LOCATION 62 CUMBERLAND AVE CBL 013 L002001

**RE: Planning Board Review - 62 Cumberland Ave - Project ID 10-79900017
(ECO Capital, LLC)**

Please find attached 7 copies of the revised Site Plan and response letter for the above-mentioned project. Comments from staff and peer reviews have been addressed below with our responses to each comment in bold.

NEW 3-UNIT BUILDING

DRAWING: **BUILDING SETBACK AT REAR**
 SCALE: 1/4" = 1'-0" *Handwritten: Plan Scale per*
 DATE: NOV.03.2010 DRAWN BY: RTL
 REVISED:

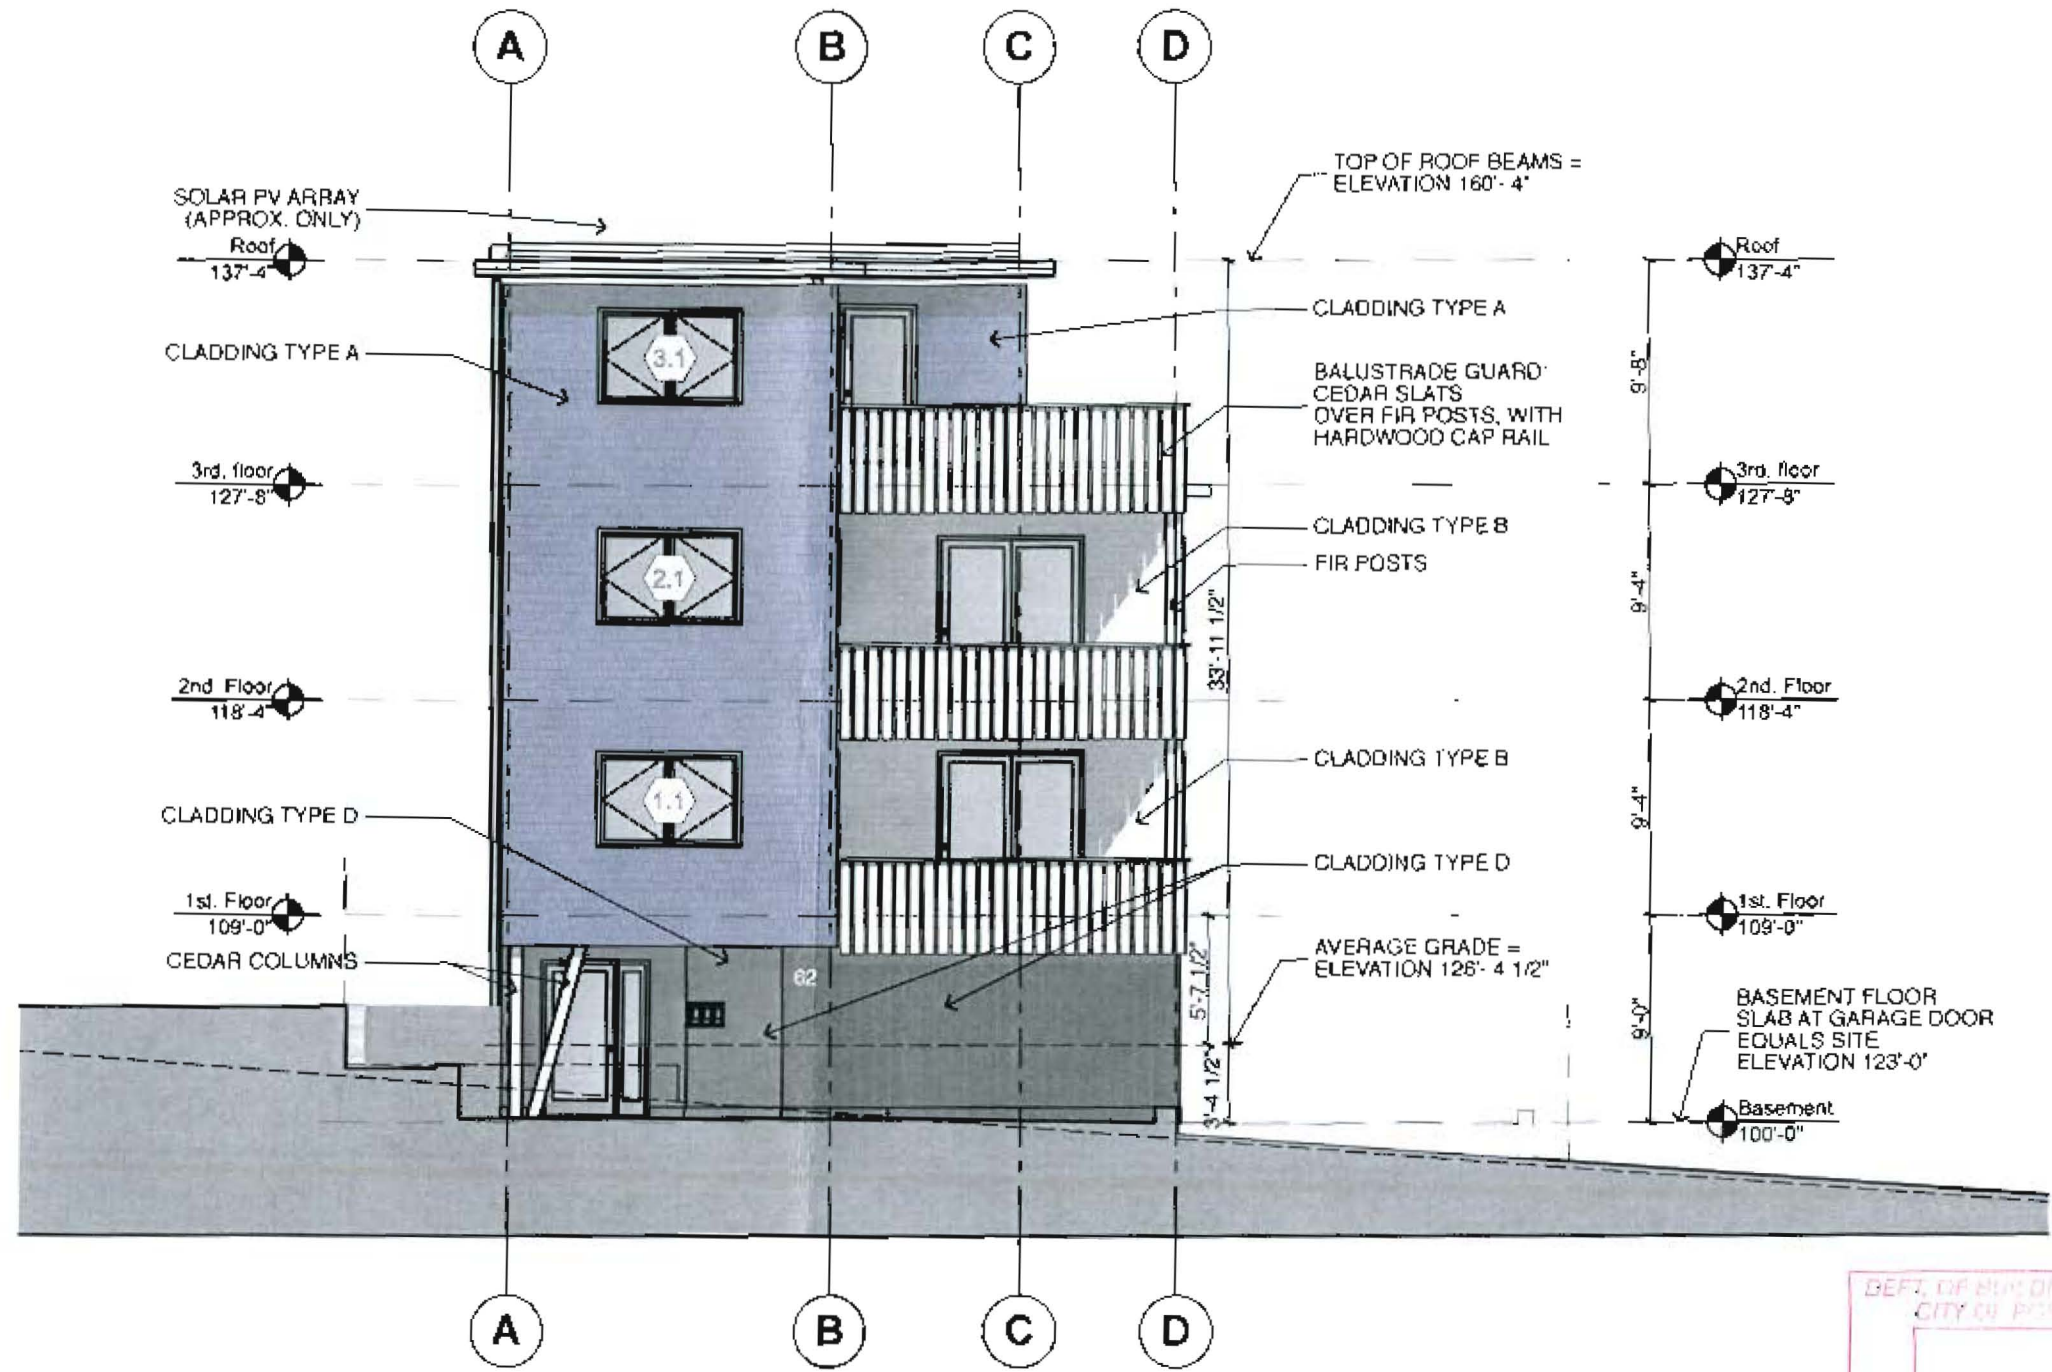
32.6
33.958

66.558 ÷ 5 = 13.32' min

see close up sheet of this submittal

ABUTTERS BUILDING 1 STORY

may need to be certified by Surveyor

11.03.2010 Revised height for Permit application (see SK.02)
(using 2x12 upper roof joists)
Height above average grade = 33'-11 1/2"

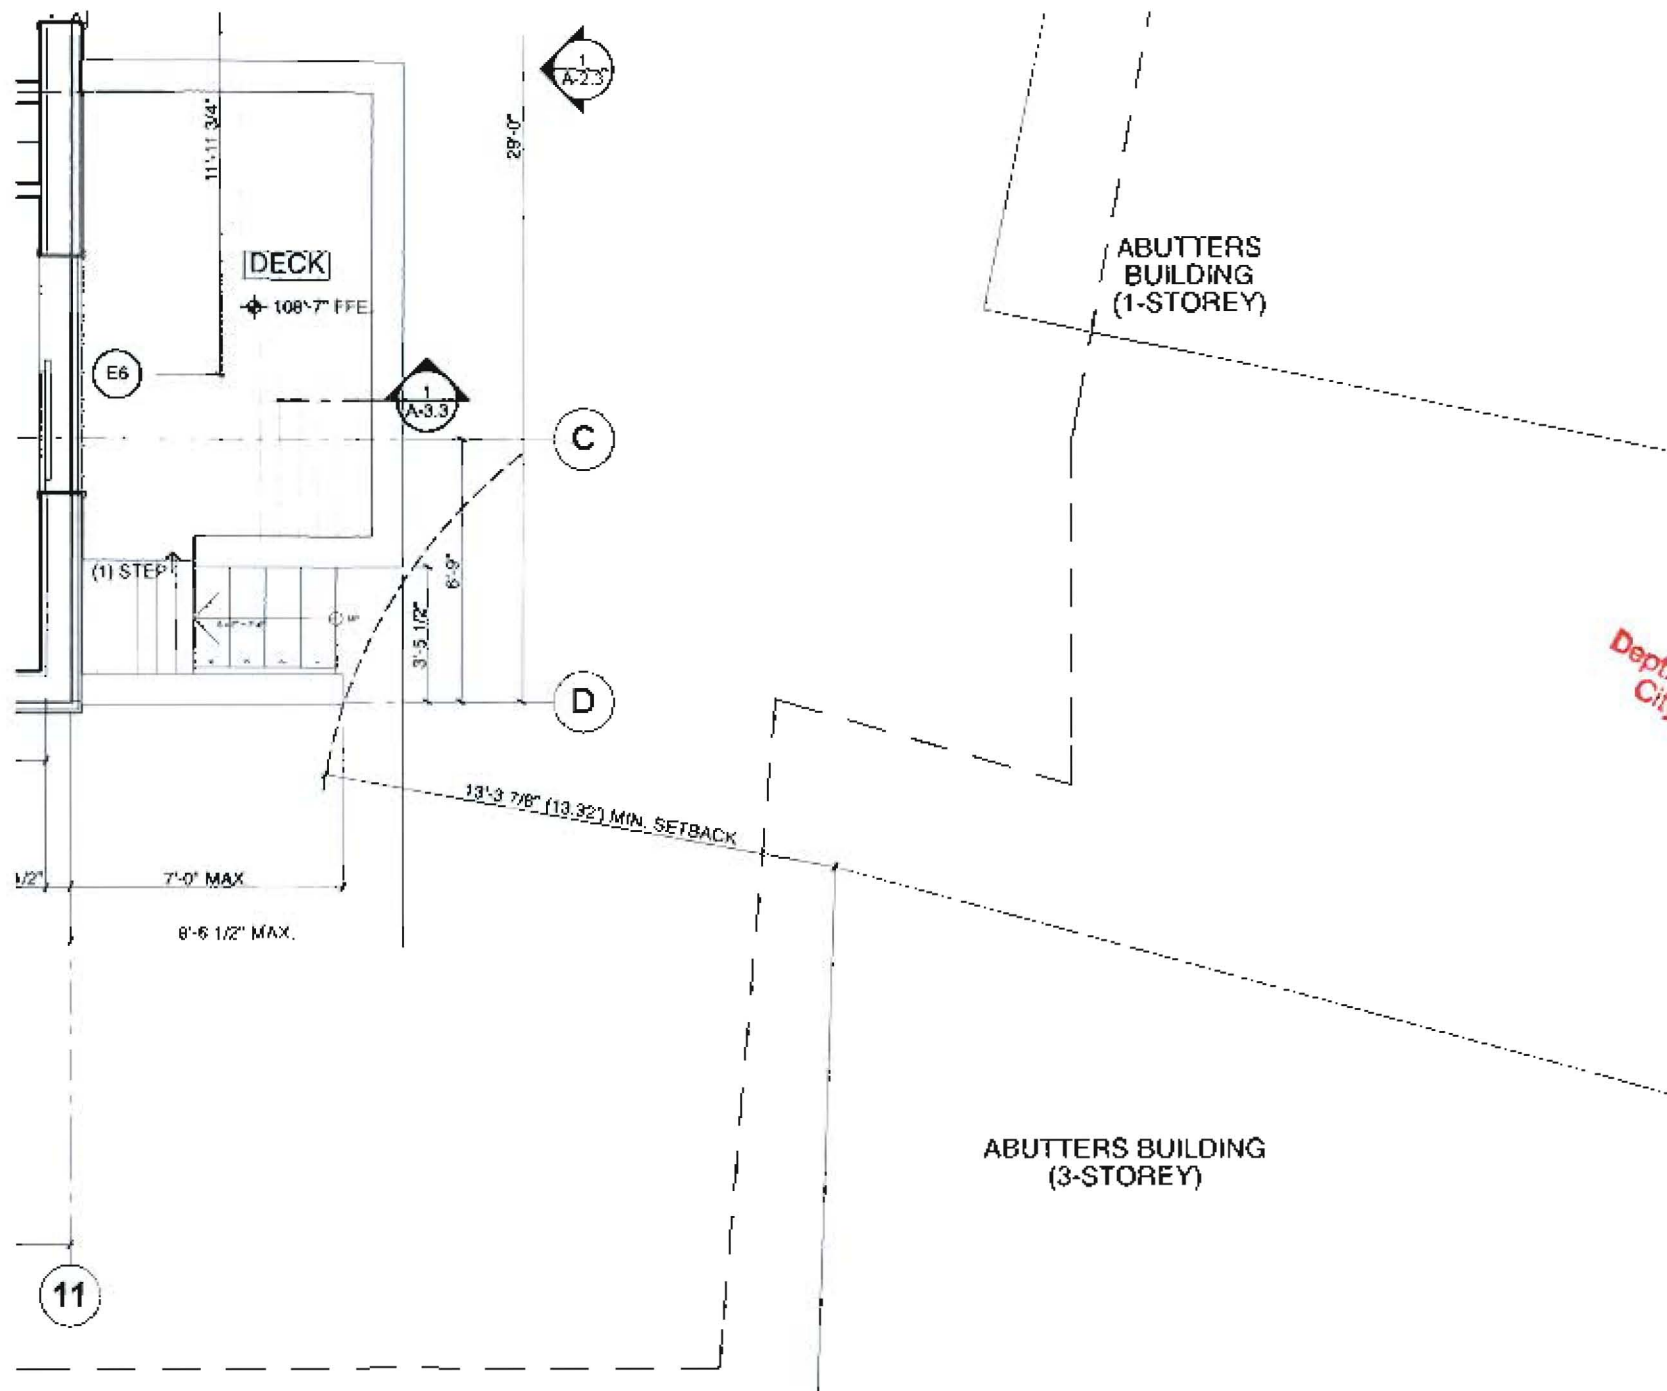
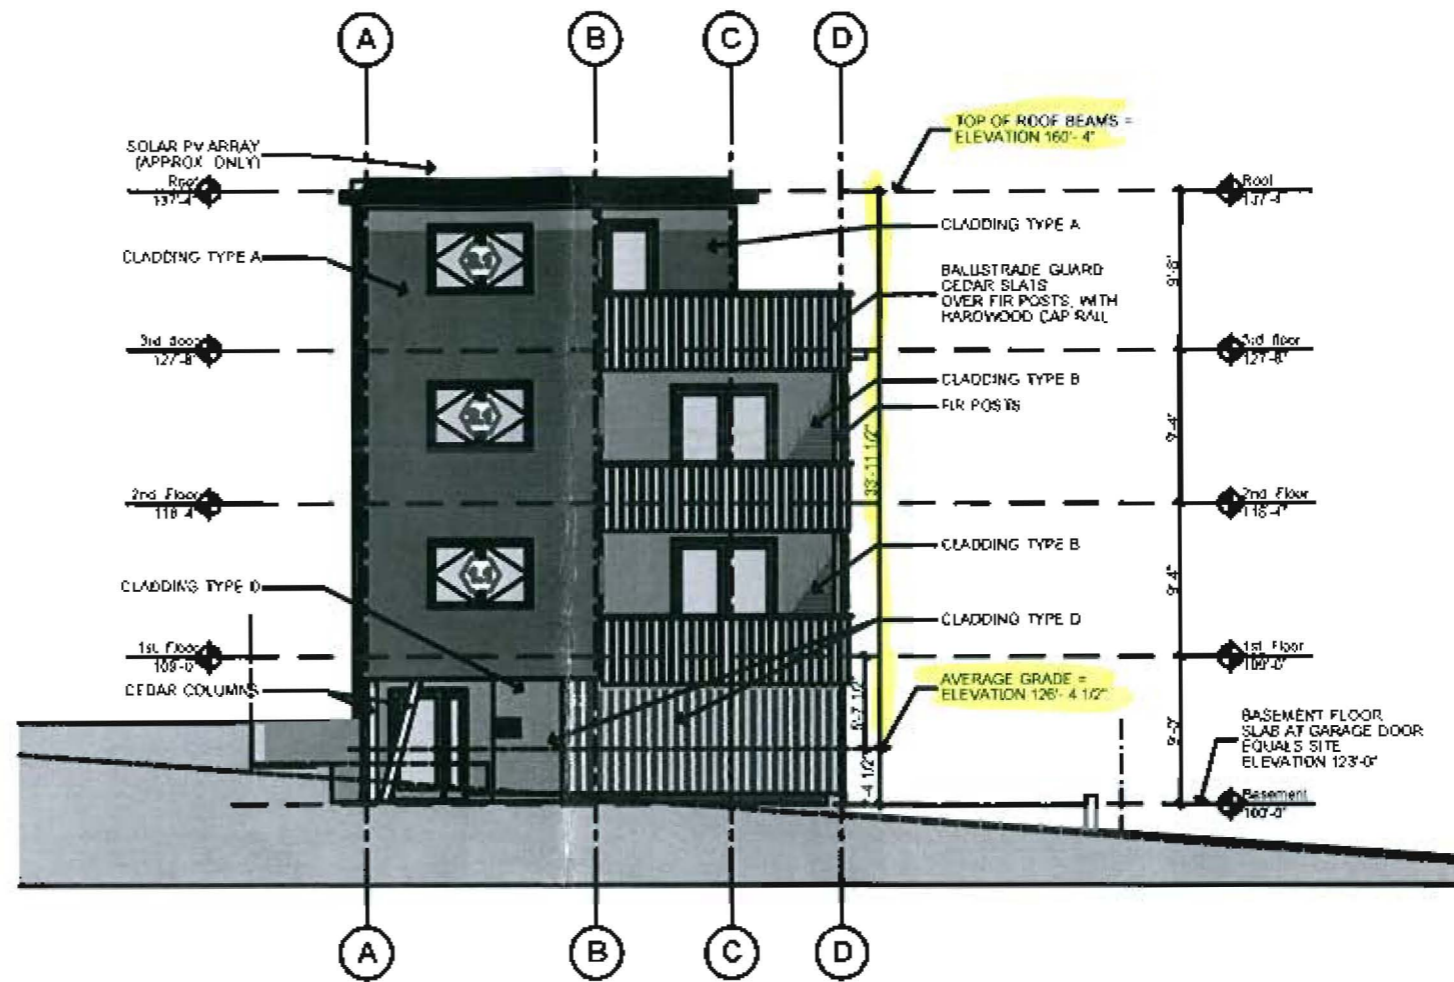
I understand, from Mike White, that you are satisfied that we can adjust the upper roof beams from 2x8's to 2x12's without any conflict with our overall maximum building height. The upper roof structure & insulation will then match that of the lower roof (ie. Detail 2 on A4.1).

Mike indicated that you understood that the proposed building height was 32'. Please note that the current proposed height is in fact 33'-7 1/2", from average grade to top of roof beams, as shown on A2.1 (N-E elevation). Changing the upper roof joists from 2x8's to 2x12's will add 4" to the building height, making the proposed height 33'-11 1/2" above average grade. Average grade elevation is 126'-1 1/2", as shown on A2.1, making the top of the proposed 2x12 upper roof beams at 160'-1".

I understand that you would like us to provide revised elevations, A2.1, that show the new proposed building height following the change to 2x12 beams for the upper roof. Please let me know if an electronic PDF is all that you need, or if a stamped hard copy is required also.

09.24.2010 Height shown on Permit application (see A2.1).
(using 2x8 upper roof joists)
Height above average grade = 33'-7 1/2"
